MINATO MARU / ENGINE ROOM H1

JS127-ER-H1-03 | CAD implementation amendment | 31 October 2026

MINATO MARU / H1 LADDER AND TOP LANDING

JS127-ER-H1-04 | Corrected access detail | 1:20 at A2 | mm

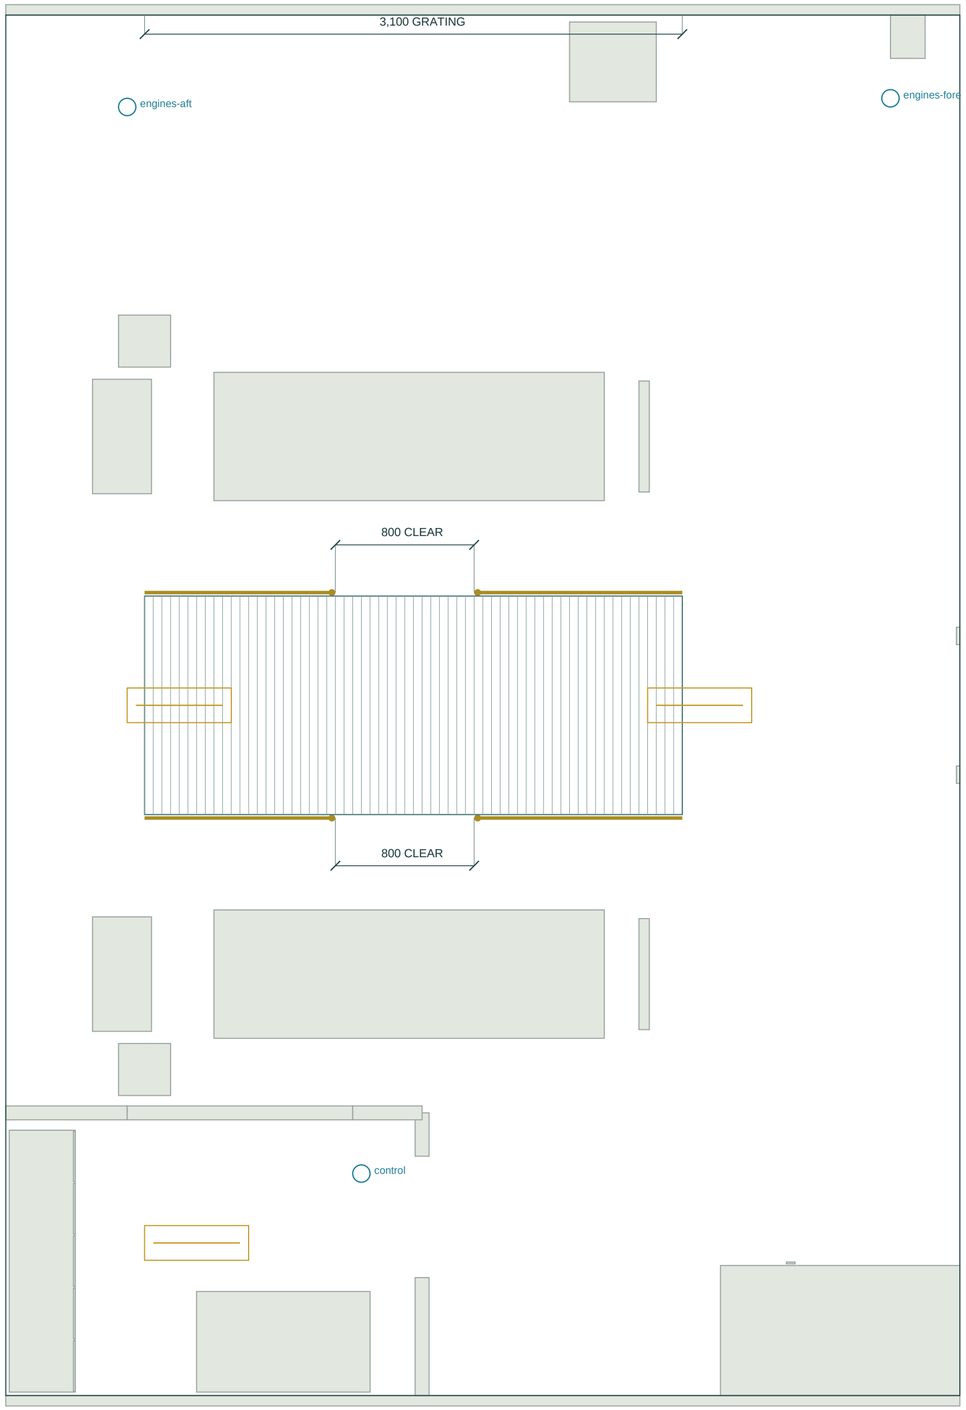
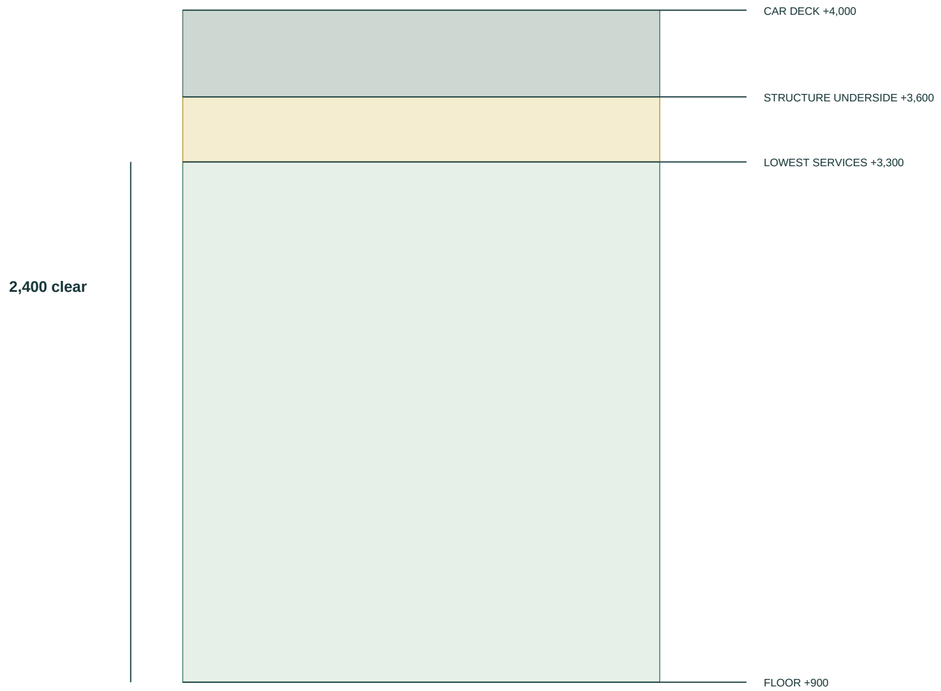
Rail posts: X10,380 and X11,220; diameter 40. Inner faces leave 800 clear.

Both inboard engine rails have the service opening. Outside rails remain.

Doors X10,900 / 14,000 / 19,000 / 22,500: 2,100 high; widths 700/800/750/700.

Five new luminaire reservations: 600 x 200 x 50; underside +3,400.

Working corridor: 1,260 between 40 mm inboard rails; floor top +900.

LONGITUDINAL SECTION / X forward from transom; Z above keel

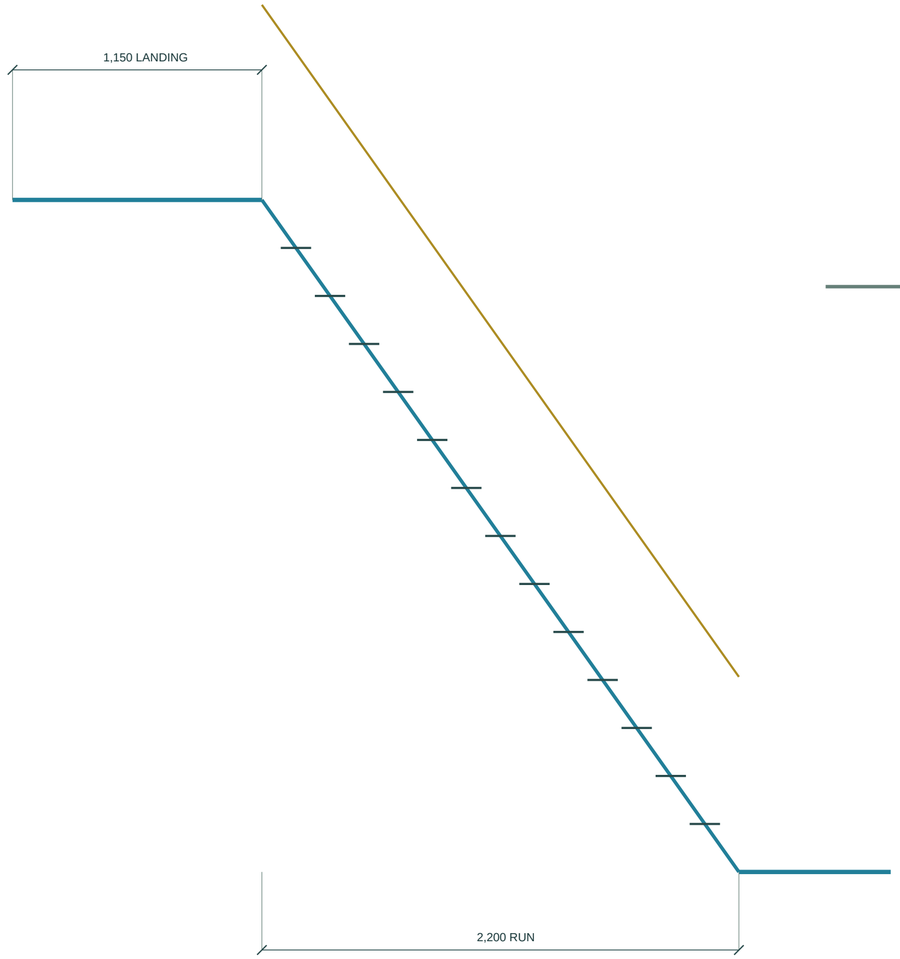
The longer ladder requires a landing behind its head. Relocate the casing P side door; do not enter mid-flight.

New side-door opening X5,300-6,400; clear longitudinal opening 1,100.

Top landing X5,250-6,400: 1,150 long, above the same +4,000 car deck.

Ladder head X6,400; foot X8,600; rise 3,100; nominal angle 54.64 degrees.

14 risers at 221.43; nominal going 157.14. Flight is an inclined ladder.

Walk down and back up using the new door and landing, not old X6,900.

PORT LOBBY / DOOR AND BENCHES / 1:30

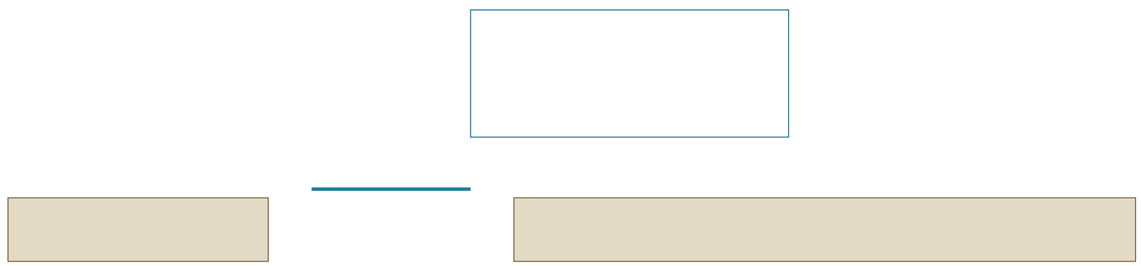
Door X5,300-6,400. Benches X3,200-5,000 / X6,700-11,000.

Retain total bench length 6,100; redistribute 1,000 forward.

JS127-ER-H1-05 | Gangway and crew station | 1:20 at A2 | mm

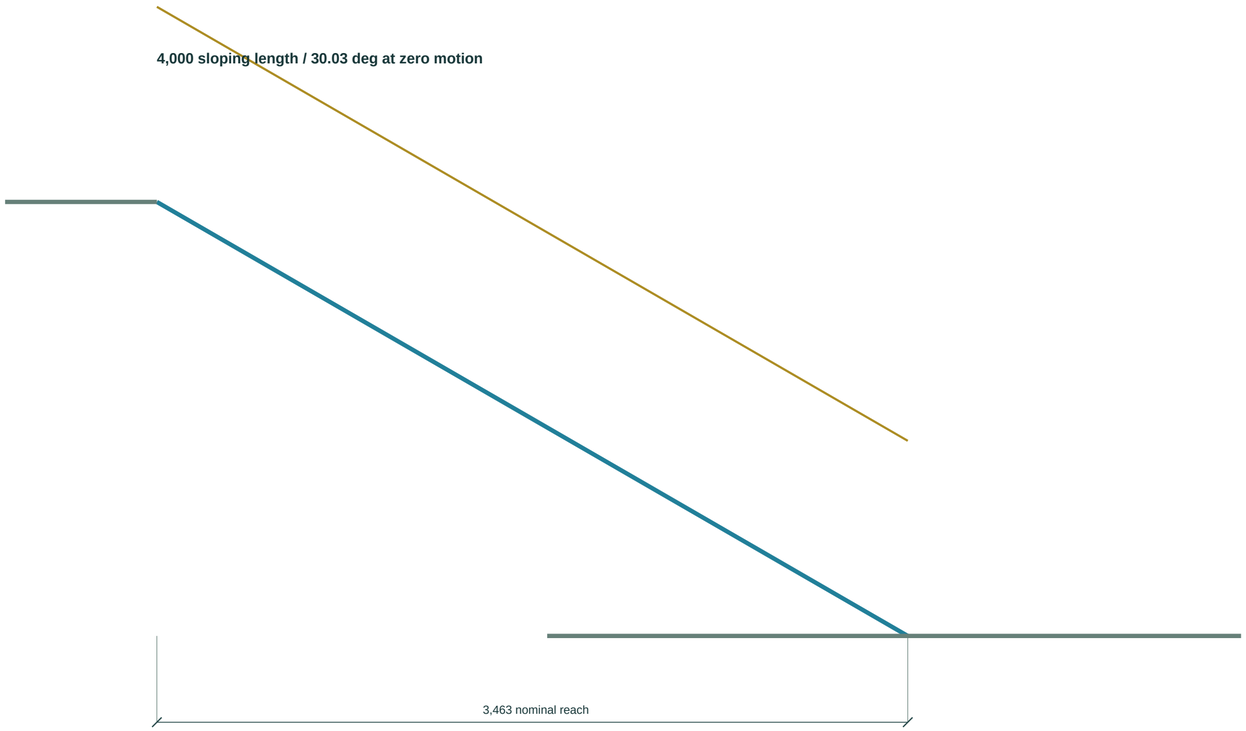
Raised vehicle deck: extend the boarding gangway rather than leave an unsupported step from the pier.

Gangway: 4,000 long x 1,400 gross width; retained side handrails.

Fold upright under passenger deck; 4,200 clear zone reserves 200 margin.

New length maintains about 30-degree nominal boarding inclination.

Forward mooring station follows actual forecastle floor +6,460 above keel.

Crew post height derives from the bow-house top +60, not old 3.56 local.
